AMENDMENT NO. 1 NOVEMBER 2014

IS 3196 (PART 2) : 2006 WELDED LOW CARBON STEEL CYLINDERS EXCEEDING 5 LITRE WATER CAPACITY FOR LOW PRESSURE LIQUEFIABLE GASES

PART 2 CYLINDERS FOR LIQUEFIABLE NON-TOXIC GASES OTHER THAN LPG — SPECIFICATION

FIG. 3 IMPACT TEST WITH FLAT SURFACE

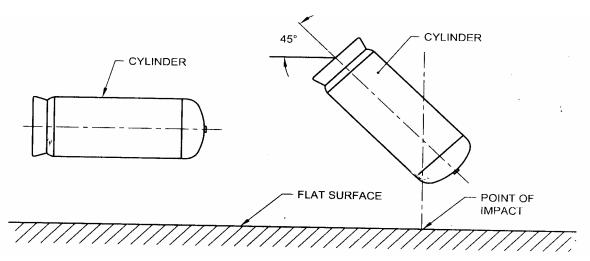
Two un-pressurised cylinders shall each be impacted with the surface parallel to the cylinder. The cylinders shall then be impacted on the shoulder of the end, with the surface at 45 to the cylinder axis (*see* Fig. 3).

- a) After impacts, the pressurised cylinders shall not leak.
- b) Cylinders subject to the burst test shall meet the requirements of 17.3.
- c) Cylinders subject to the fatigue test shall meet the requirements of 17.2.

FIG. 6 IMPACT TEST WITH AXIS PERPENDICULAR TO EDGE, L

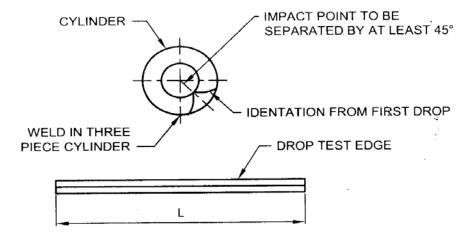
Two un-pressurised cylinders shall each be impacted with the edge parallel to the cylinder axis (*see* Fig. 5). The cylinders shall then be impacted with the edge perpendicular to the cylinder axis (*see* Fig. 6). The position of the two impacts shall be separated by a minimum of 45° round the cylinder circumference.

- a) After impacts, the pressurised cylinders shall not leak.
- b) Cylinders subject to burst test shall meet the requirements of 17.3.
- c) Cylinders subject to the fatigue test shall meet the requirements of 17.2.

FIG. 7 ORIENTATION FOR 1.2 m DROP ONTO FLAT SURFACE

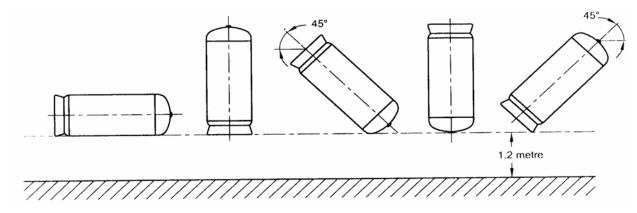
The cylinders shall each be dropped twice into a flat surface from 1.2 m, in each of the five different orientations illustrated in Fig. 7 that is, 10 drops per cylinder.

- a) After ten drops, the cylinders shall not leak.
- b) Cylinders subject to the burst test shall meet the requirement of 17.3.
- c) Cylinders subject to the fatigue test shall meet the requirements of 17.2.
